Centre Plan Package A | Developer letters and submissions

(February 23 – May 8, 2018)

ZONING/PROPERTY OVERLAY

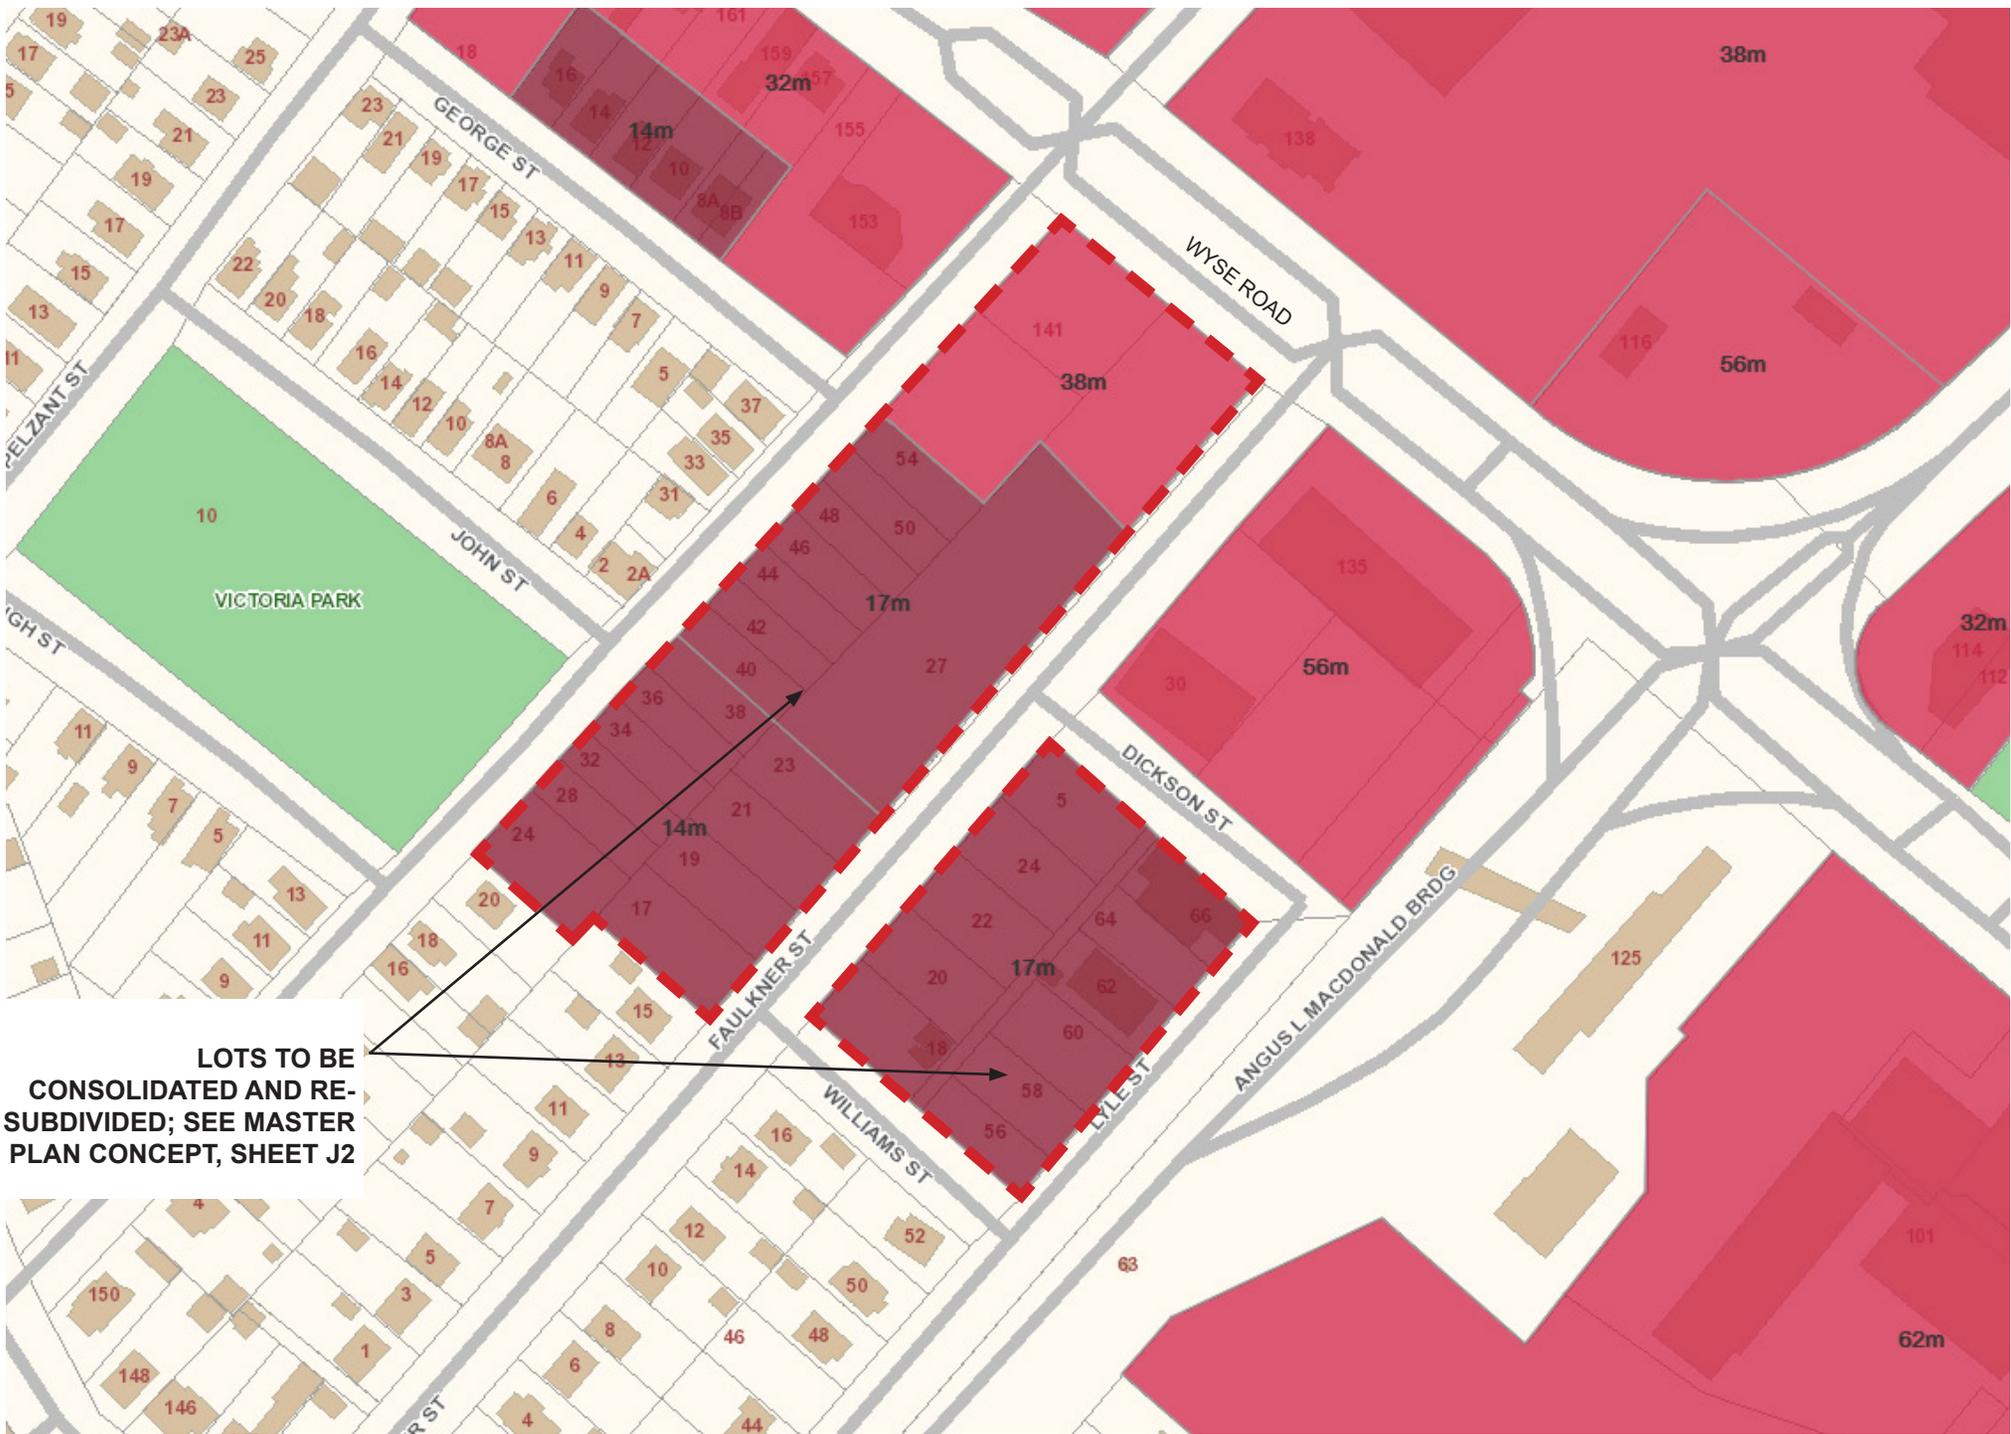
INCLUDE PIDS 00064675, 41260530
IN HR-2 ZONING

LOTS TO BE CONSOLIDATED AND RE-SUBDIVIDED; SEE MASTER PLAN CONCEPT, SHEET J2

PROPOSED DESIGN

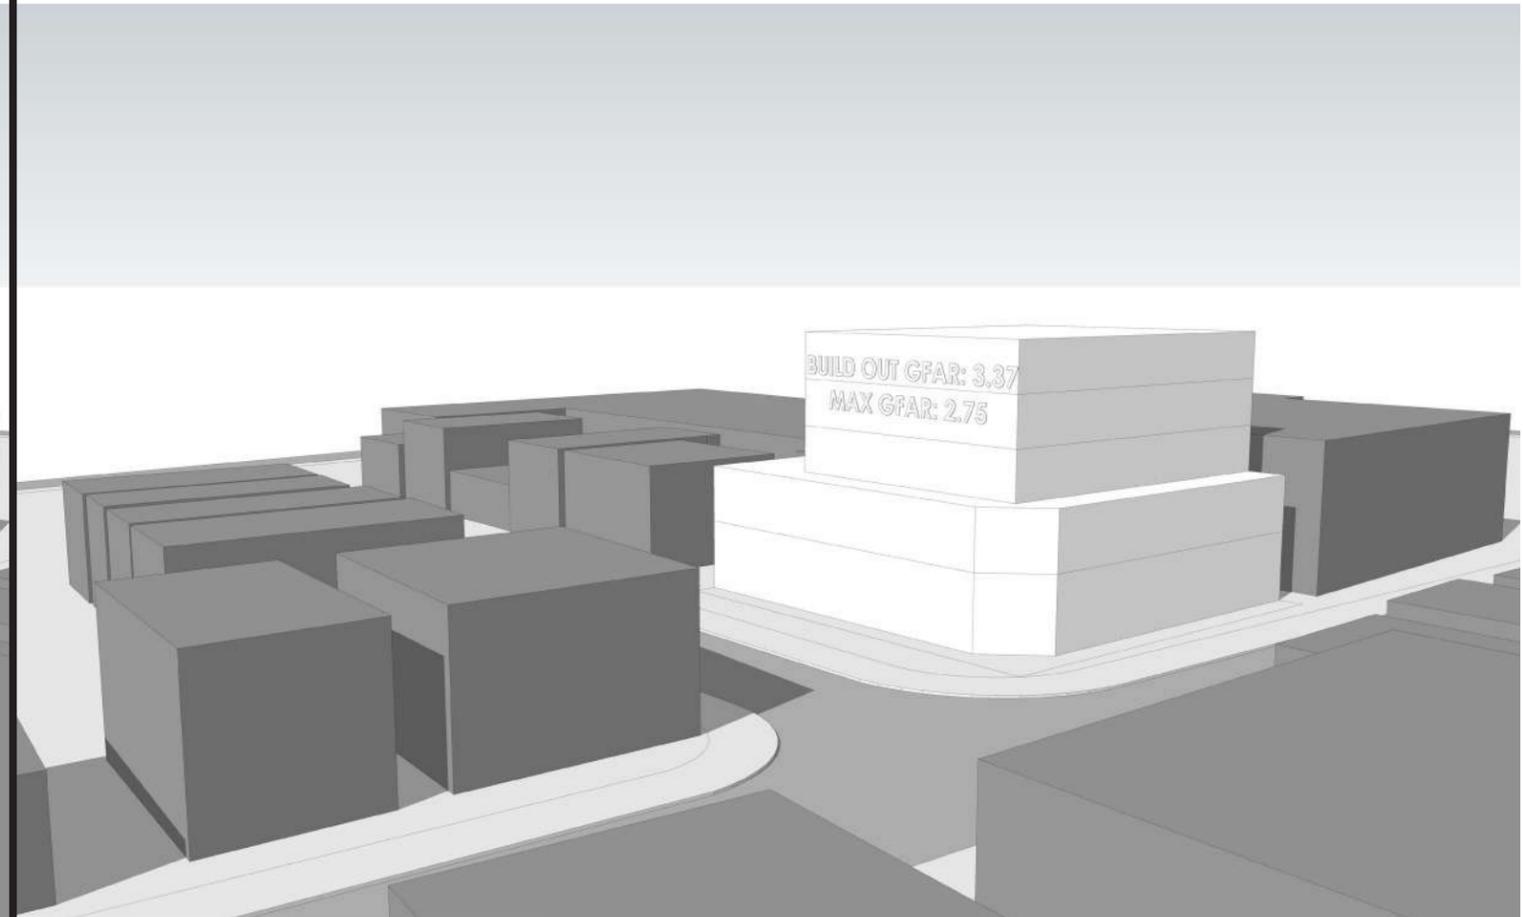
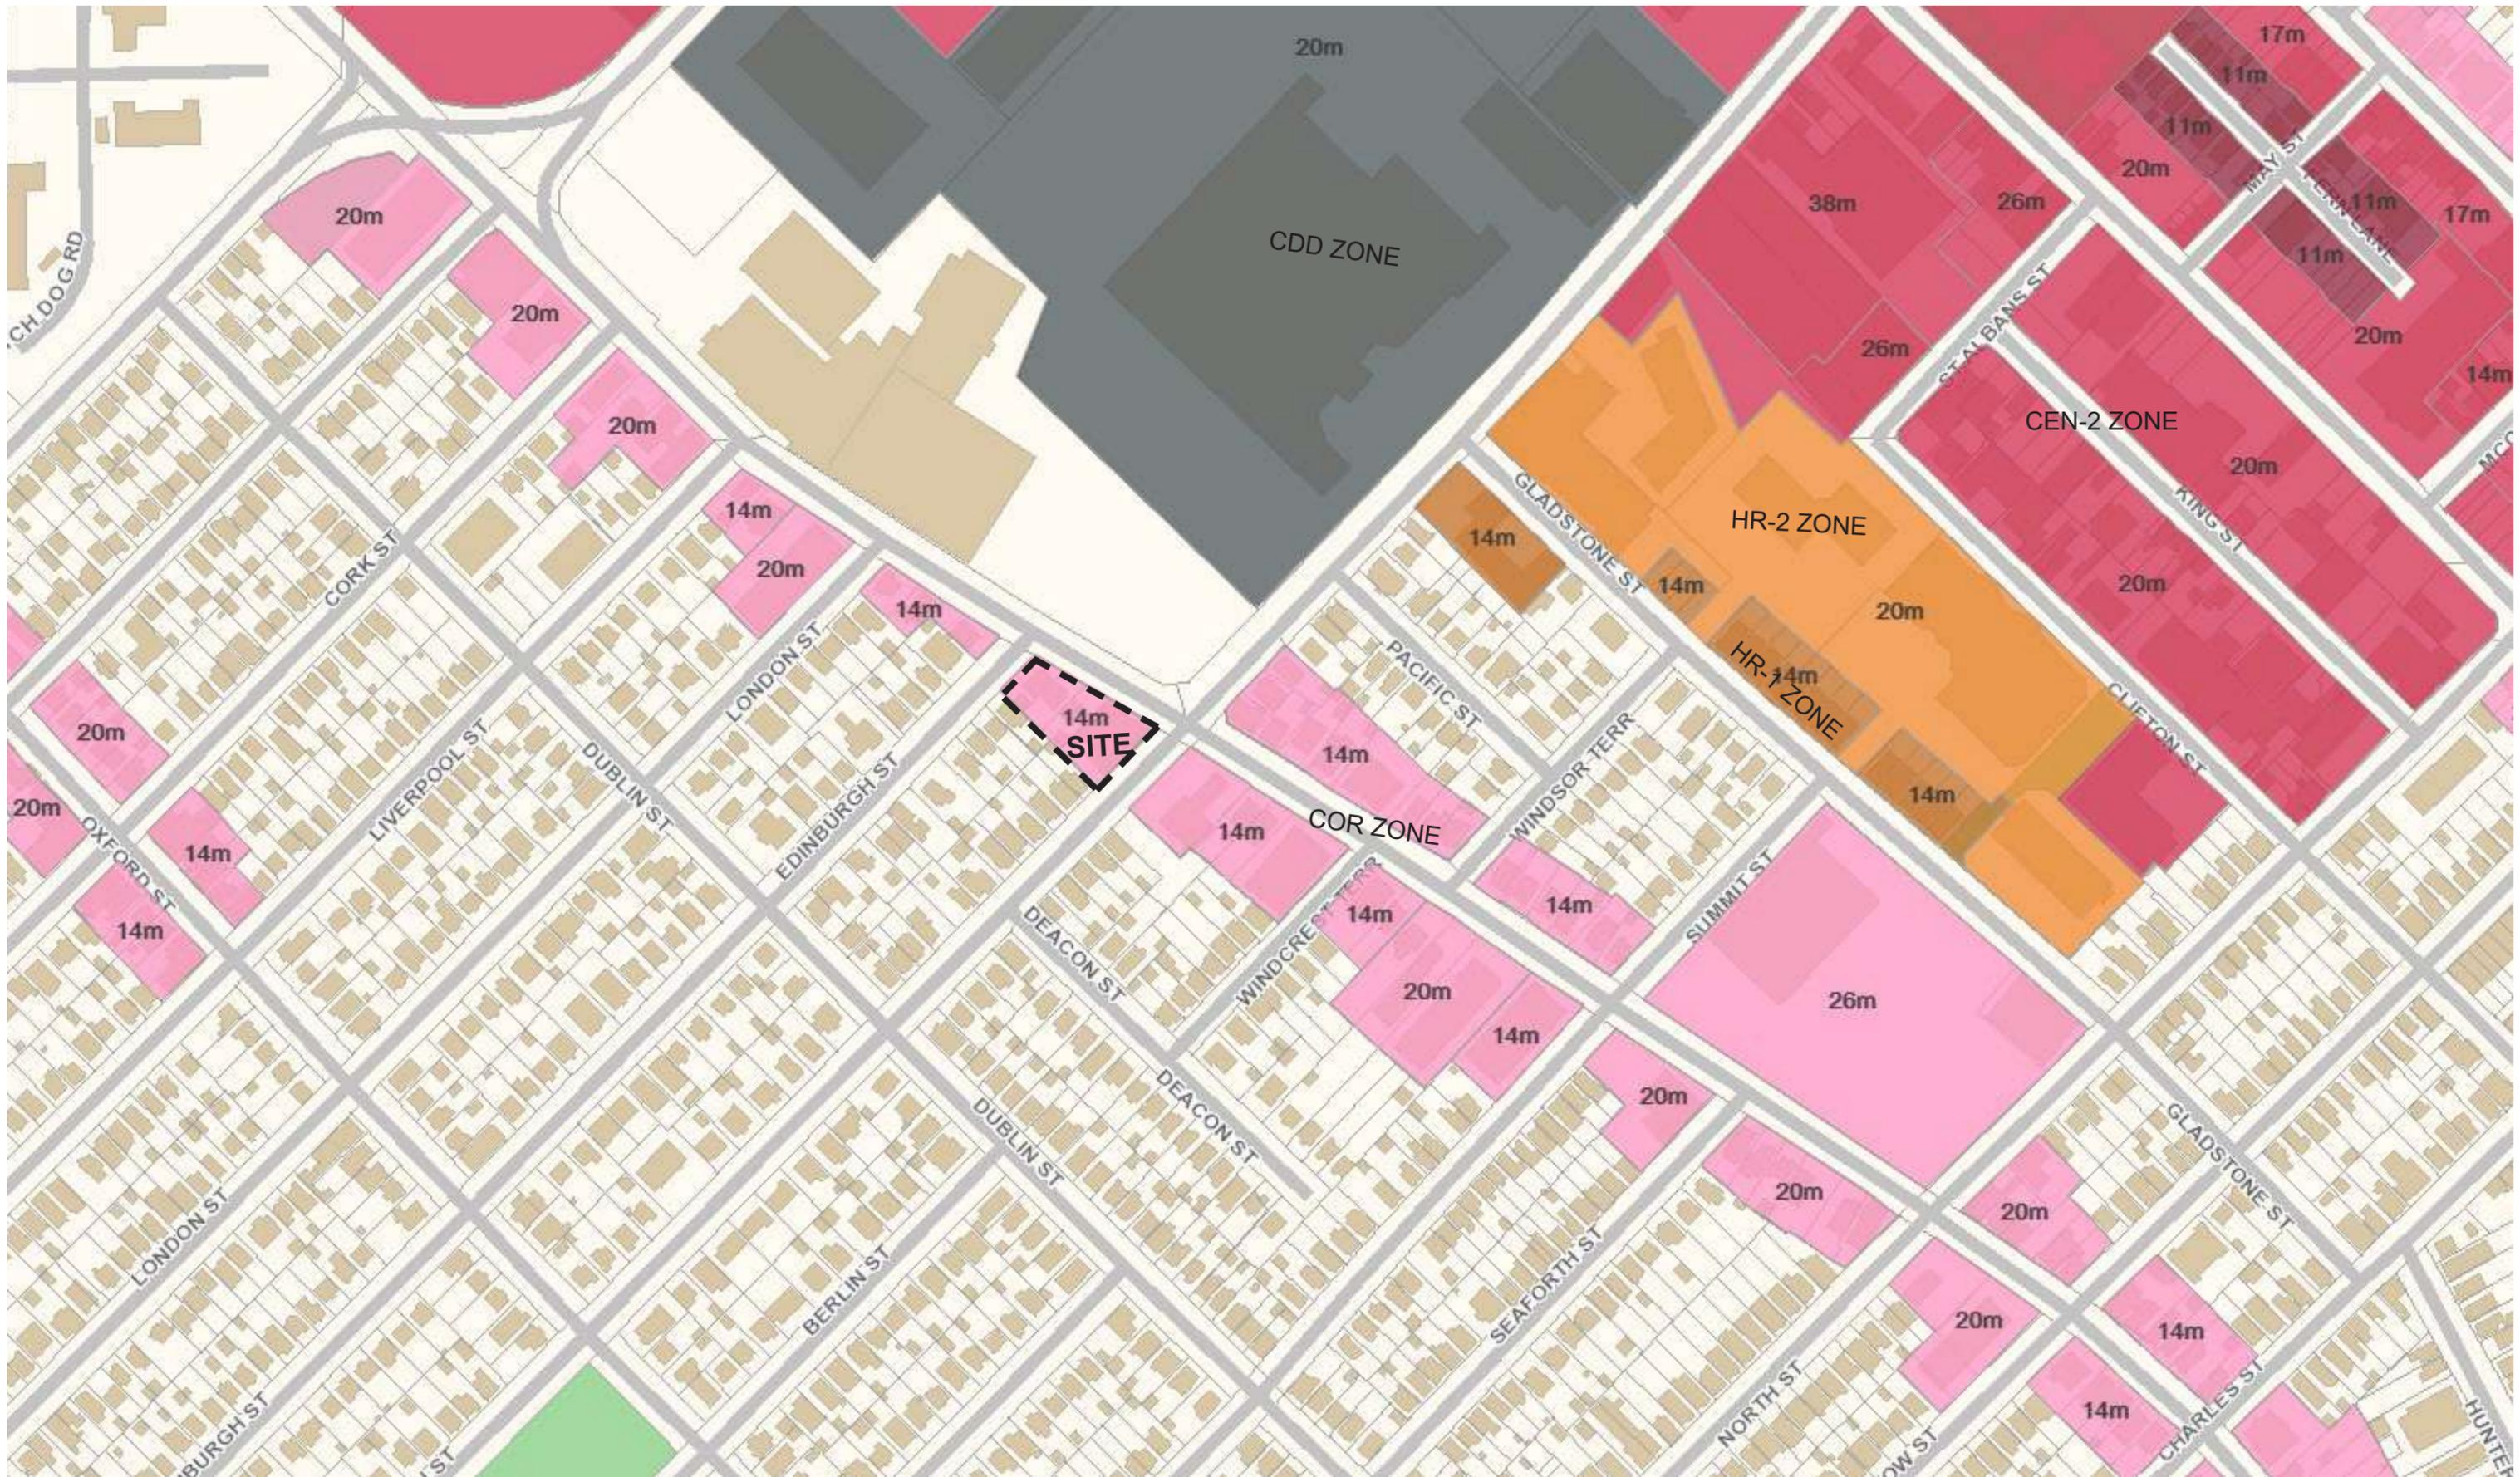
STREETLINE SETBACK		Min. 1.5 m (±4.9 ft) from Windsor St. Min. 3.0 m (±9.8 ft) from Almon/ Edinburgh St.	±1.2 m (±4.0 ft) from Windsor St. ±0.0 m (±0.0 ft) from Almon St. ±3.5 m (±11.3 ft) from Edinburgh St.	Our proposed setbacks are relative to existing setback contexts. Can there be flexibility via variances for conditions like this?
STREETWALL STEPBACK		Min. 2.5 m (±8.2 ft)	±1.5 m (±5.0 ft) ±3.0 m (±10.0 ft)	Considering size of lot, the proposed stepback could be increased to 2.5m.
SIDE YARD SETBACK		Min. 3.0 m (±9.8 ft)	0.0 m	
SIDE YARD STEPBACK		Min. 2.5 m (±8.2 ft)	0.0 m	
REAR YARD SETBACK		Min. 6.0 m (±20.0 ft)	±0.0 m- 6.0 m (±0.0 ft- 20.0 ft)	Consideration should be made for lots with multiple frontages to allow for street condition to be consistent with preexisting 'side yard' setbacks and separation between buildings less than 6m.
REAR YARD STEPBACK		Min. 2.5 m (±8.2 ft) Above 11.0 m	±2.4 m- 7.6 m (±7.9 ft- 25.0 ft)	Would recommend a stepback at the height of the streetwall (proposed 3storeys) vs 11m parameter which may or may not align pending ground floor height.

LANDSCAPE REQUIREMENTS	ABUTTING ER DESIGNATION	L2	-	
	STREETYARD	Min. 60%	±100%	
	SIDEYARD	N/A	N/A	Unclear in LUB on requirements. Even if setback parameter is 0m, there should be provisions should the design lend itself for a side yard.
	REAR YARD	Min. 50%	±58%	Recommending excluding drive isles and ramps from 50% landscape requirement as most parking entry points will occur at the transitional zone (away from major intersection and aligns with internal building logistics/programming).
VIEWING TRIANGLE		Streetline intersection at 6.0 meters (±20.0 ft)	±4.4- 4.6 meters (±14.4-15.1 ft)	Recommending removal of this parameter all together
